SAFETY EVALUATION BY THE OFFICE OF NUCLEAR REACTOR REGULATION

SUPPORTING AMENDMENT NO. 22 TO PROVISIONAL OPERATING LICENSE NO. DPR-45

LACROSSE BOILING WATER REACTOR (LACBWR)

DOCKET NO. 50-409

FIGURE 1

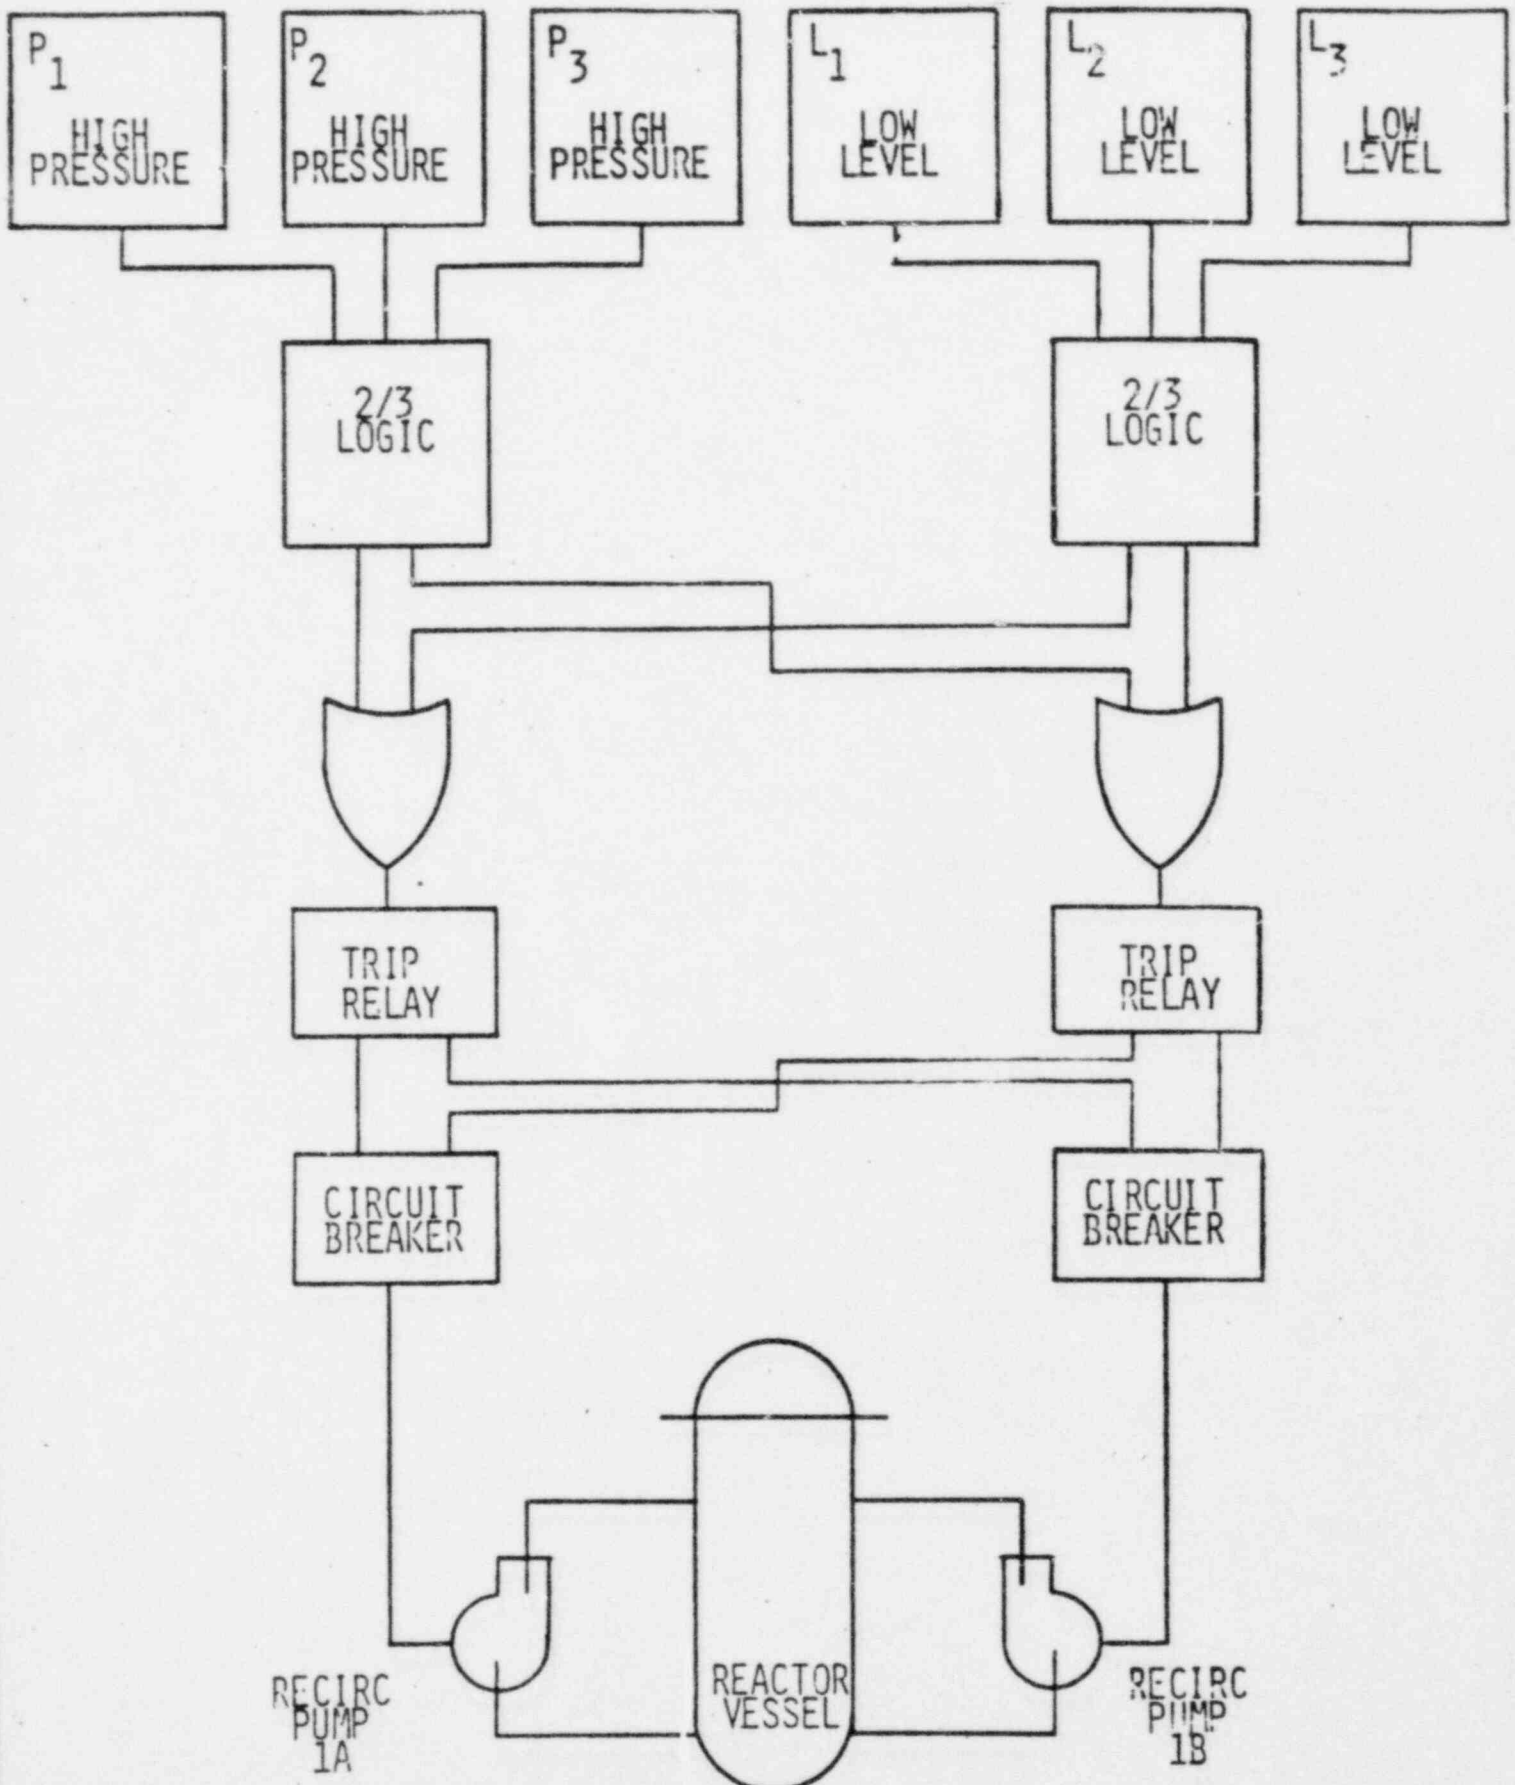
Referring to Figure 1, the LACBWR RPTS will perform the function of disconnecting the main power to both reactor recirculation pump circuit breakers in the event of RPT conditions in either of the redundant logic trains.

A RPTS trip signal consists of high reactor pressure (> 1350 psig) or low reactor water level (-30 inches). A high pressure signal upstream of the MSIV's provides an indication that either MSIV has closed. Should the pressure sensors fail to trip the pumps, the pressure will continue to increase causing the safety valves to lift, thus, blowing down the reactor. The water level will continue to decrease below the reactor low water level scram setpoint (-12 inches). At a reactor water level of -30 inches, the RPT level backup system will actuate.

The components to be added are manufactured by Foxboro Company and are designed for use in the Consoltron equipment line presently in service at LACBWR. The pressure and level relays are arranged in a two out of three logic to energize the recirculation pump trip relays (TR1 and TR2). A signal from any one of the four logic trains will trip both pumps. The bypass switch will permit pump operation should the RPTS control circuit fail in the shutdown mode and recirculation pump operation is required. This logic system is not vulnerable to any single failure either preventing a pump trip when required or causing a pump trip when not required.

The three level channels and two of the pressure channels will share common current loops with the scram system. The current loops have independent power supplies separate from the safety drawers. The safety system scram actuations are initiated through a power supply, amplifier, comparators and relays in the safety drawers. Any failure of these components would not effect the signal to the RPT circuits and, therefore, would not disable the mitigating system.

We, therefore, find the proposed modification and the related technical specification changes to be acceptable.
